ES Service Information

File In/With:	N/A	SI0129	
		New	9-05
Equipment Affected:	See Below		
Copeland Compressor Replacement and Piping Modifications

**YCAL0014-0253/YCUL0016-0275 AND YPAL0050-0105 Styles B & Early C
COPELAND COMPRESSOR REPLACEMENT AND REQUIRED PIPING MODIFICATIONS**

FIGURE 1 – 4-PIPE AND 3-PIPE COMPRESSOR PIPING EXAMPLES

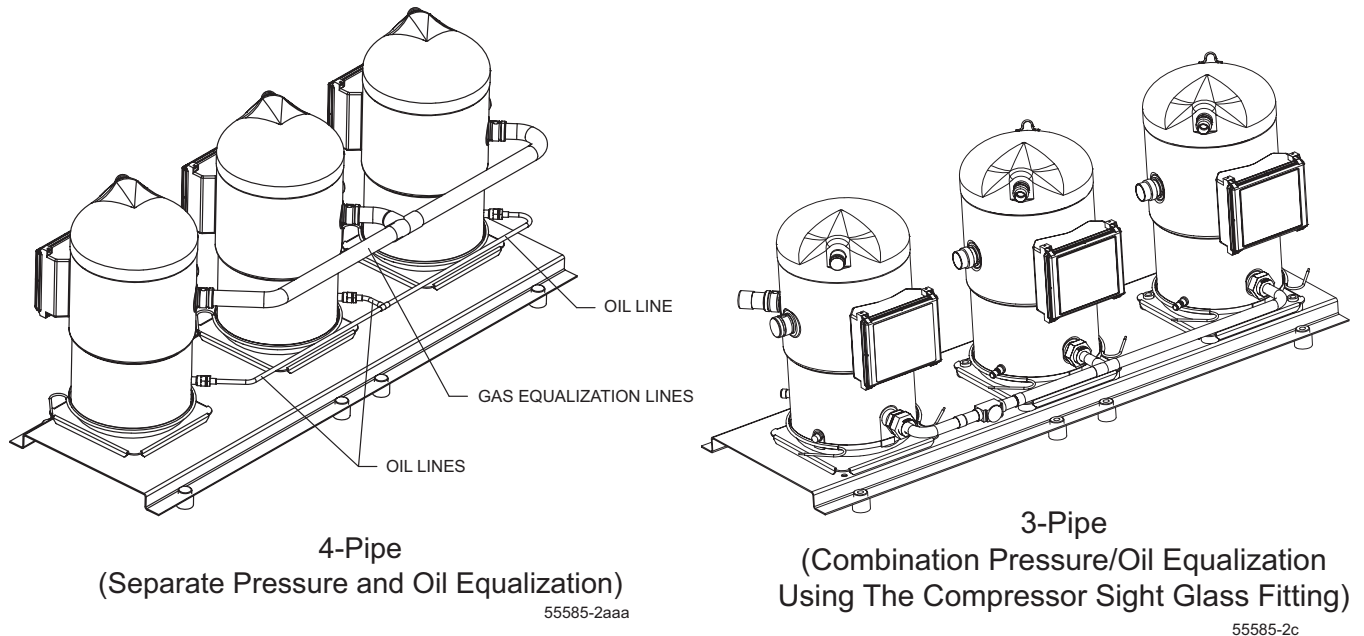
Beginning in the fall of 2004, Copeland compressors used in YCAL/YCUL/YPAL Style C models, changed from a 4-pipe system to a 3-pipe system as a result of a Copeland compressor design change to reduce cost. The original compressor design used a 4-pipe system on YCAL/YCUL/YPAL Style B and early Style C consisting of discharge, suction, pressure equalization (1 3/8") pipe, and oil equalization (3/8") lines. The new compressor design utilizes a 3-pipe system consisting of discharge, suction, and (7/8") combination pressure/oil equalization lines. Examples of the original 4-pipe and new 3-pipe piping schemes showing separate and combined pressure and oil equalization are shown in FIGURE 1.

When ordering compressors, examine the system and determine if a 3-pipe or 4-pipe system exists using the examples in FIGURE 1. If a 4-pipe system exists, order a compressor using the original part number from the unit replacement parts list, which should compare to the part numbers provided in TABLE 1. A 4-pipe compressor may be supplied while still available, depending on stock in various warehouses. Otherwise, a 3-pipe equivalent will be substituted. The model number on the original** compressor should also match the model numbers in TABLE 1. The original** 4-pipe system compressors can be easily identified by the -472 suffix in the model number of the compressor, while the original** 3-pipe system compressor model number will have a -222 suffix. 3-pipe system compressors are assigned different part numbers 015-04009-101 to -106 (R22) and 015-04009-301 to -306 (R407C). See TABLE 3, Page 13. **If a 4-pipe system exists, order kit # 015-04023-000. This kit will allow installation of the new compressor and conversion to a 3-pipe system.**

FIGURE 3 – FRAME RAIL REMOVAL

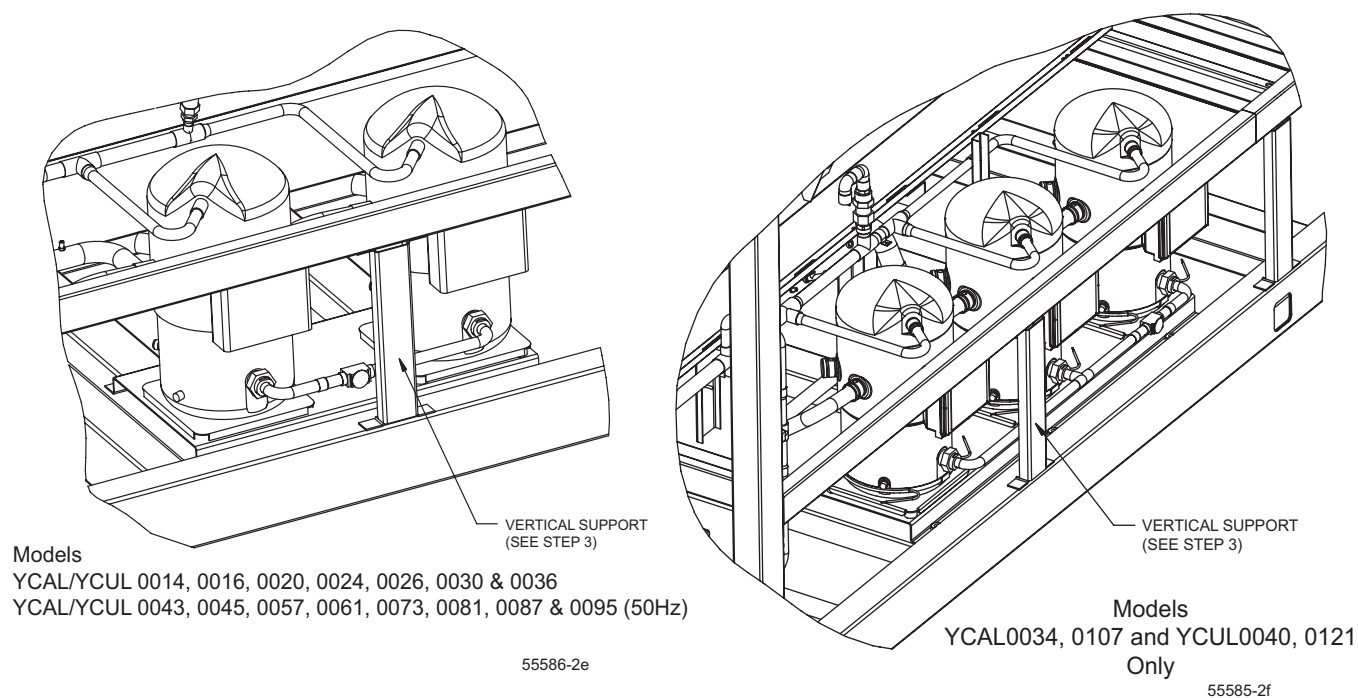
1. Be sure the kit contains all the parts listed in the bill of materials.
2. Remove the refrigerant from the system with the defective compressor(s) using environmentally friendly procedures. If the system has compressor isolation valves, the valves can be closed and only the refrigerant in the compressor(s) will need to be removed.
3. Temporarily remove the center vertical support from the frame rail on YCAL/YCUL models 0014-0040 and YCAL/YCUL models 0043-0121 (50Hz). The rail will later be notched and refitted. See FIGURE 3 below:

FIGURE 4 – OIL AND PRESSURE EQUALIZATION LINE REMOVAL

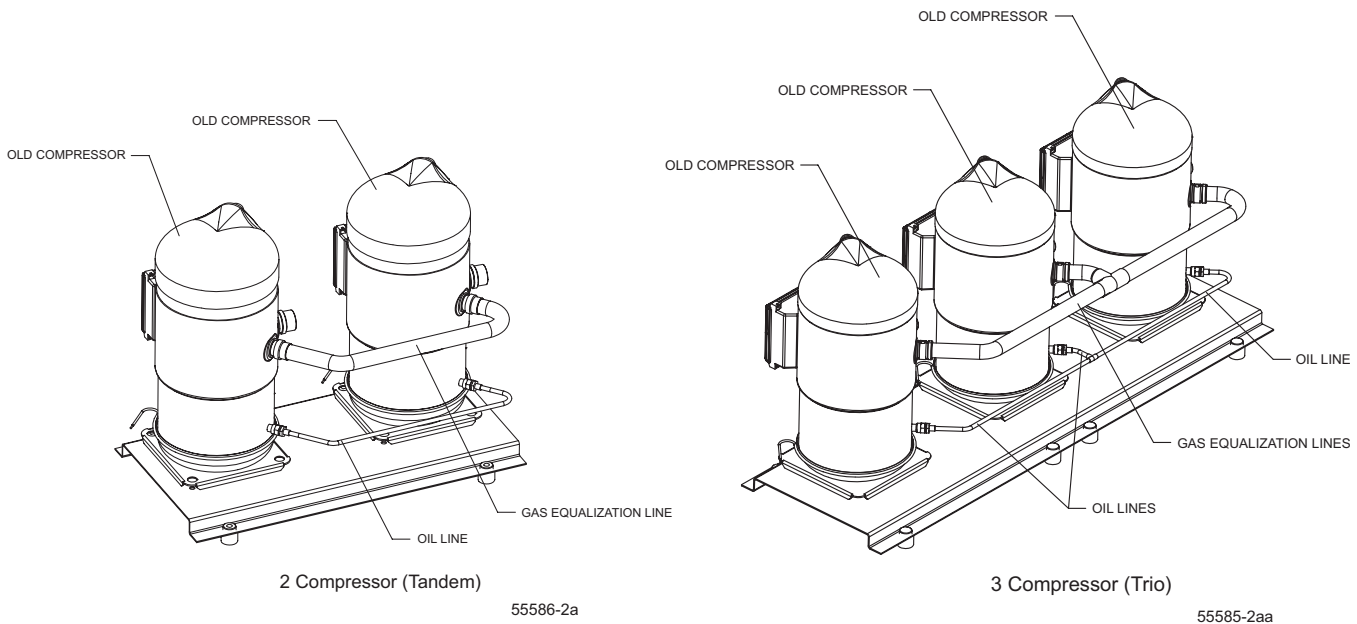
4. Cut the oil and gas equalization lines 2” from the end of the compressor connections. See FIGURE 4 on the following page. Take special care not to spill oil when the lines are cut. ***Oil will run out of the compressors and lines. Be sure to take steps to catch it.***
5. Cut the suction and discharge line(s) of the failed compressor(s) to within approximately 1” of the compressor connections.

FIGURE 5 – CAPPING OFF GAS EQUALIZATION LINES ON 4-PIPE SYSTEM COMPRESSORS

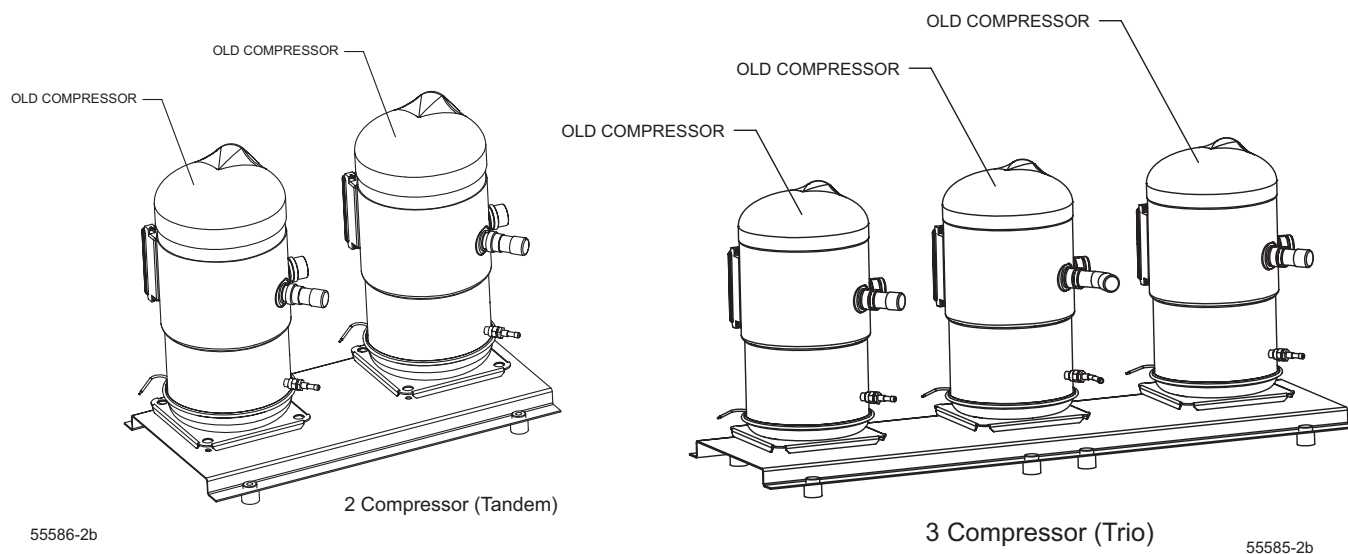
6. Remove the failed compressor(s) and replace it (them) with the new one(s). Refer to Service Information letter SI0074 for return of the failed compressor.
7. Braze item 15 (PIPE CAP) and item 16 (PIPE CAP) into the oil and gas equalization line 2" stubs still connected to each *compressor that will not be replaced*, as shown in FIGURE 5 on the following page. ***When brazing the cap to the oil line connection, it is recommended the line should be disconnected from the compressor to avoid damage to the seal at the compressor connection.*** Be sure to always use a nitrogen purge when brazing the pipe and caps. Always use Silfoss 15 (15% brazing rod) when brazing piping. Place wet paper towels or heat sink compound on the compressor connections to avoid damaging the compressor or the existing braze joint.

FIGURE 6 – GASKET, NUT AND SLEEVE INSTALLATION (REF. TABLE 2, PAGE 3)

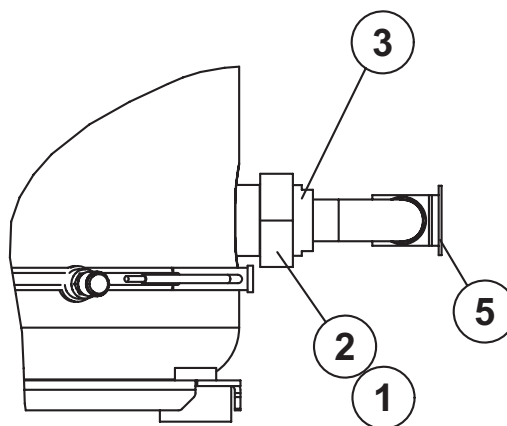
8. Remove the sight glasses from both the existing and new compressors to allow installation of the combination gas/oil equalization line.
9. Install Items 1 (Gasket), 2 (Compressor Nut), and 3 (Sleeve) in each "new" compressor sight glass threaded fitting. Loosely thread the connection together. **DO NOT tighten at this time.** After the piping is brazed in step 11, final torque item 2 against item 3 to 125-133 ft-lbs to obtain a metal-to-metal contact as shown in FIGURE 6.

FIGURE 7 – OLD COMPRESSOR ROTOLOCK AND GASKET/NUT/SLEEVE INSTALLATION
(REF. TABLE 2, PAGE 3)

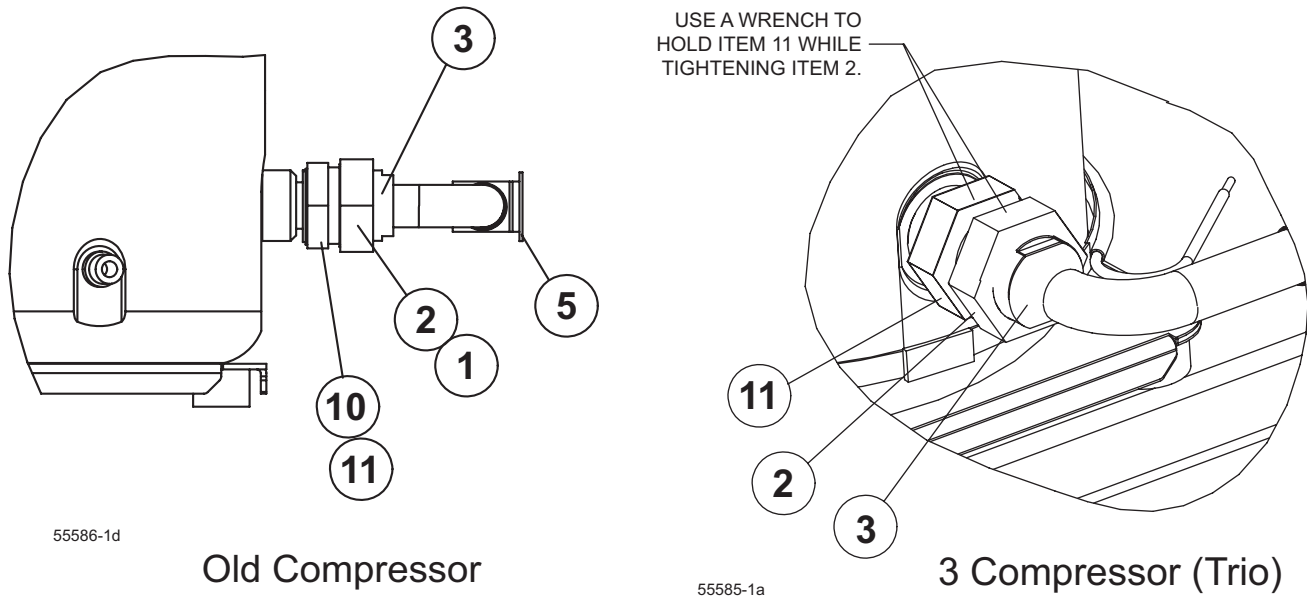
10. Install Items 10 (O-ring) and 11 (Rotolock Fitting) into each "old" compressor sight glass threaded fitting. Torque Item 11 into the compressor to 133-177 ft-lbs as shown in FIGURE 7. Install Items 1 (Gasket), 2 (Compressor Nut), and 3 (Sleeve) in each Rotolock fitting. Loosely thread the connection together. **DO NOT tighten at this time.** After the piping is brazed in step 11, final torque item 2 against item 11 to 125-133 ft-lbs as shown in FIGURE 7. Be sure to hold Item 11 with a wrench while tightening Item 2 as shown in FIGURE 7.

FIGURE 8 – TANDEM COMPRESSOR PIPING INSTALLATION (REF. TABLE 2, PAGE 3)

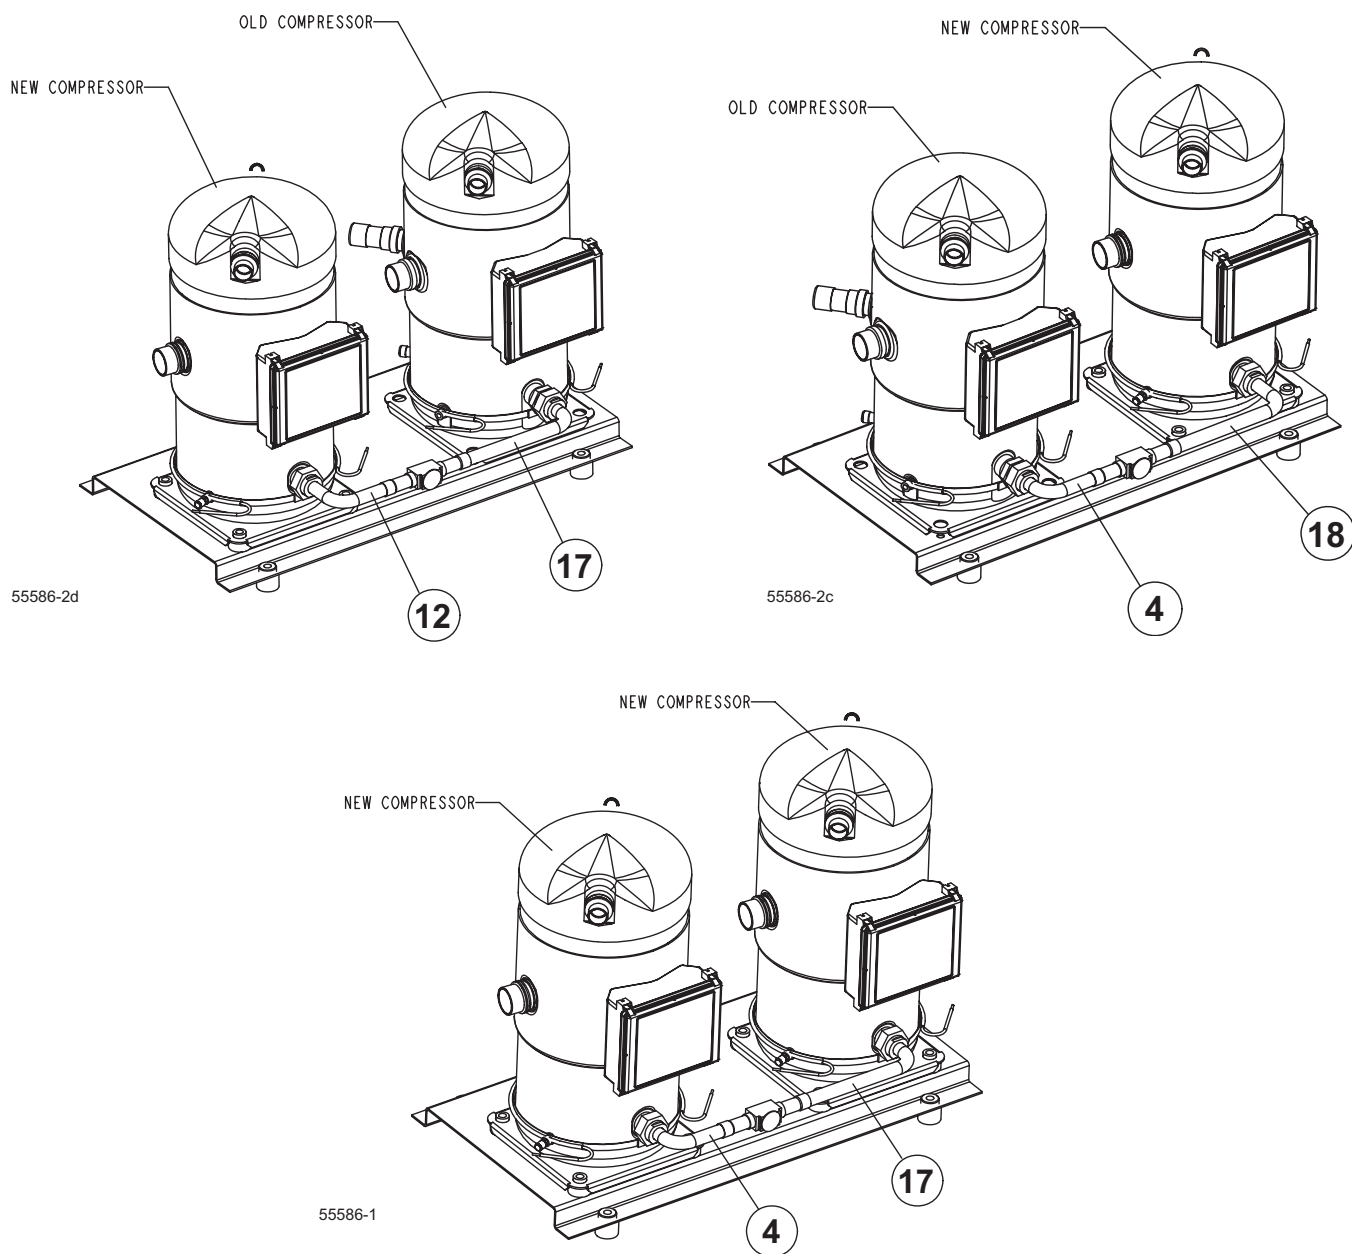
11. Install gas equalization and oil piping using the pieces shown in the following drawings. Locate the sight glass according to the location(s) the new compressors are installed. Install the sight glass at a 90 degree angle (horizontal) as shown in the drawings. See the following drawings in Fig. 8 for location of the sight glass. Be sure the sight glass is installed to avoid interference with the frame rail and be clearly visible. Remove the piping assembly from the compressor connections to braze the assembly. Also remove the gasket (1) while brazing. This will assure the o-ring (10) and gasket (1) are not damaged by the heat. Braze using Silfoss 15 (15% brazing rod). Be sure to use a nitrogen purge and wrap the sight glass with wet paper towels when brazing. Fit the completed piping assembly to the compressors and tighten the threaded fittings as outlined in Steps 9 and 10 (see pages 9 and 10).

FIGURE 10 – NOTCHING AND RE-INSTALLING THE SUPPORT

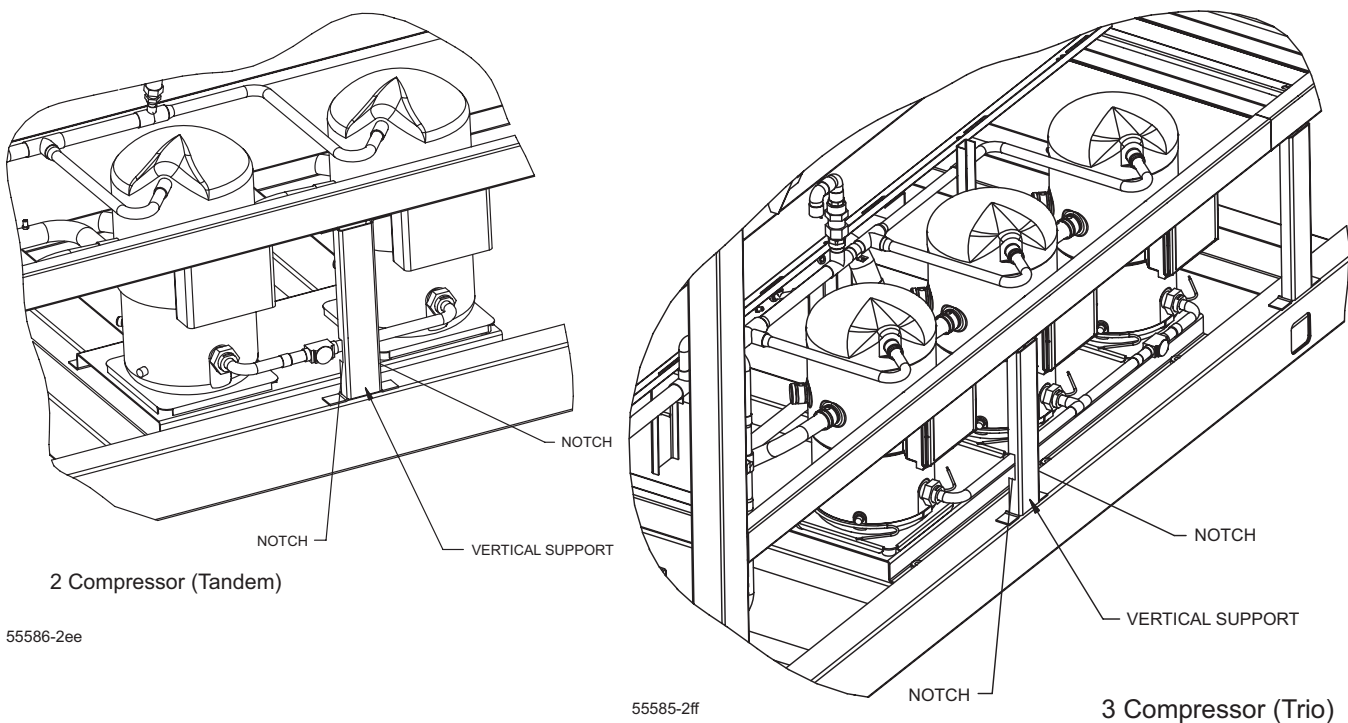
12. Cut two 0.375" notches in the center support of the YCAL0014-0034, YCAL0043-0107 (50Hz), YCUL0016-0040 and YCUL0045-0121 (50Hz) as shown in FIGURE 10. Re-install the center support and check for interference. Further modify the notch as required.
